CITY COUNCIL STAFF REPORT

SUBJECT: APPROVAL OF A CONFORMITY REPORT FOR A PROPOSED PARKING STRUCTURE ON TRIBAL TRUST LAND CONSISTING OF A FOUR-LEVEL 850-SPACE PARKING STRUCTURE ON A 2.8 ACRE PARCEL LOCATED AT THE SOUTHEAST CORNER OF CALLE ENCILIA AND AMADO ROAD, ZONE RA (RESORT ATTRACTION), SECTION 14 SPECIFIC PLAN (CASE 5.1390).

Case No. 5.1390 – Conformity Report

SITE PLAN
EXHIBIT D

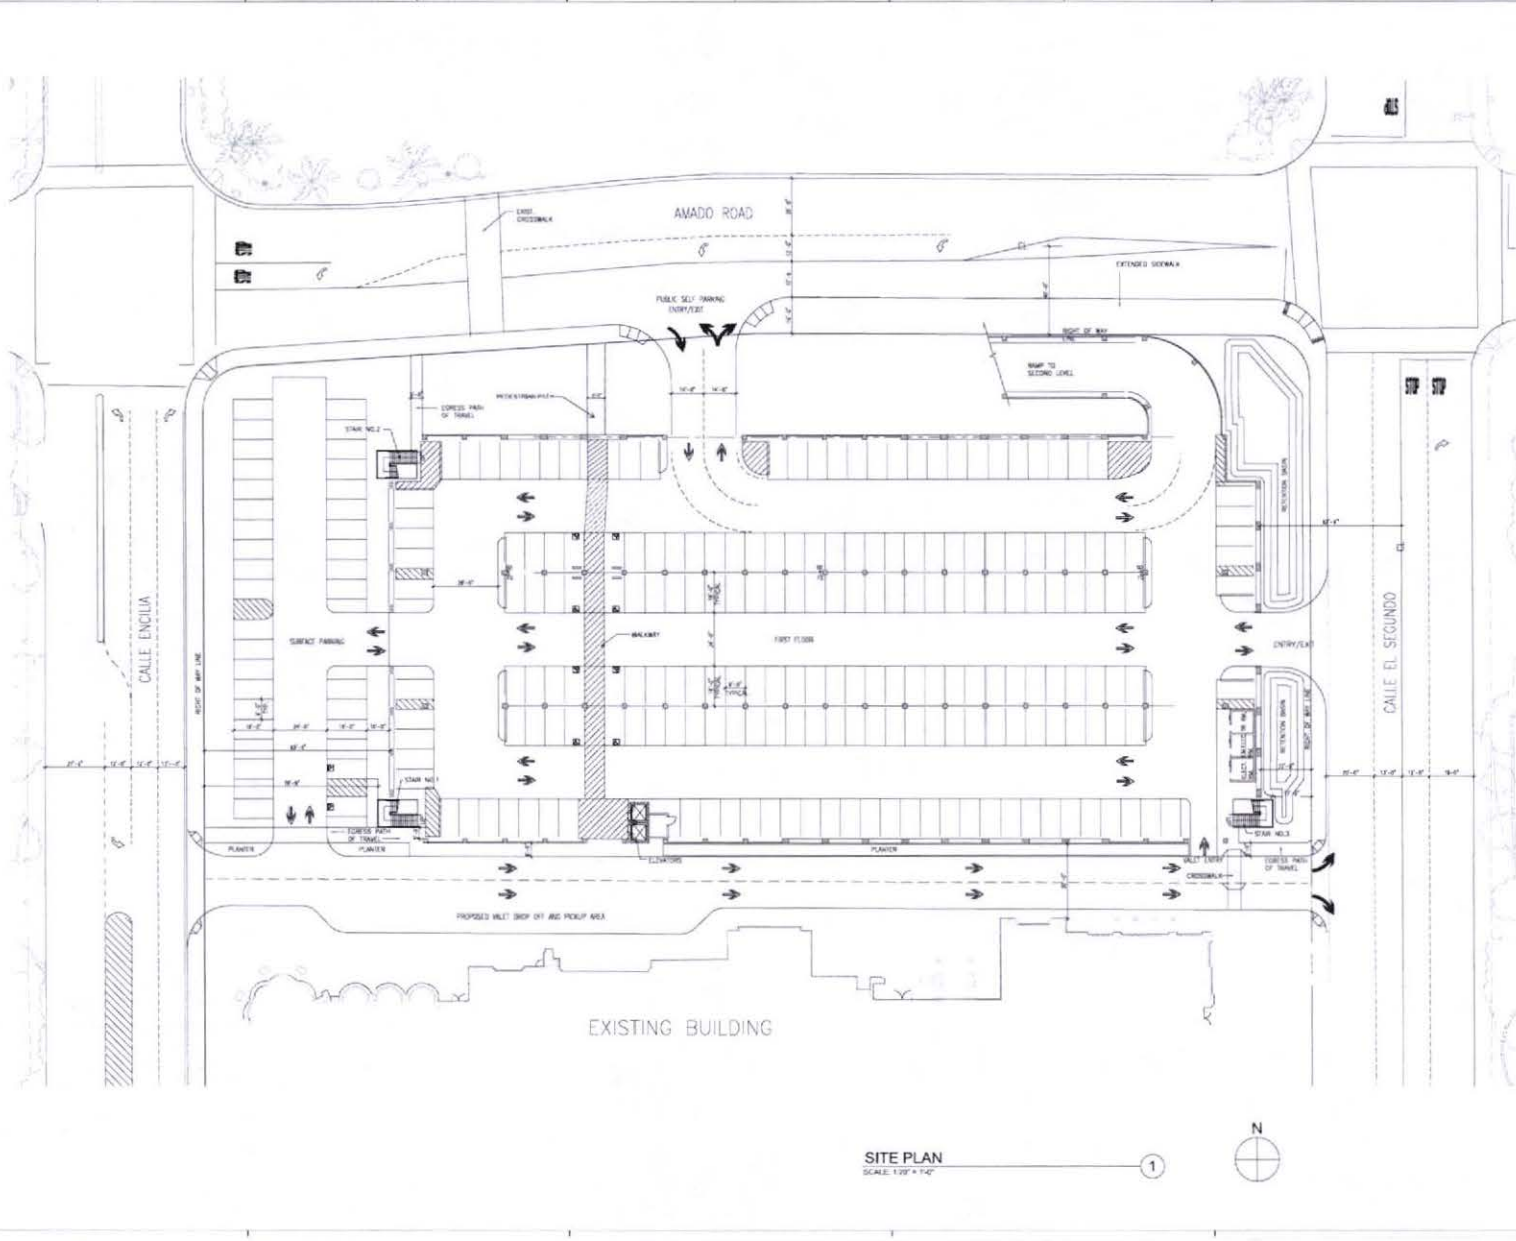
- Amado Road: The specific plan recommends a nine-foot wide parkway (4' landscape and 5' sidewalk) on Amado Road. The submitted plan depicts a sidewalk of approximately eight feet in width adjacent to the curb; it is recommended that the sidewalk be adjusted to conform to the configuration described in the specific plan. In addition, the plan recommends the addition of Class II bicycle lanes on Amado Road, which could be considered as part of any future street improvements.

- Calle Encilia: The plan recommends an eight-foot wide sidewalk along Calle Encilia, which is shown on the submitted plans. Class II bicycle lanes are also recommended along Calle Encilia, which could be added with future street improvements.

- Calle El Segundo: The plan recommends that a five-foot wide sidewalk and four-foot wide parkway be installed adjacent to the curb along Calle El Segundo; the plan depicts a sidewalk of approximately eight feet in width and does not include a parkway between the sidewalk and the street. It is recommended that the plan be revised along the El Segundo frontage to conform to the recommendations of the specific plan.

- PLN 4. Bicycle Parking. It is recommended that the project provide secure bicycle parking facilities on site for use by patrons and employees.
- PLN 5. Streetscape Standards. It is recommended that the streetscape treatment along the Amado Road and Calle El Segundo frontages be revised to conform to the standards contained in the Section 14 Specific Plan.
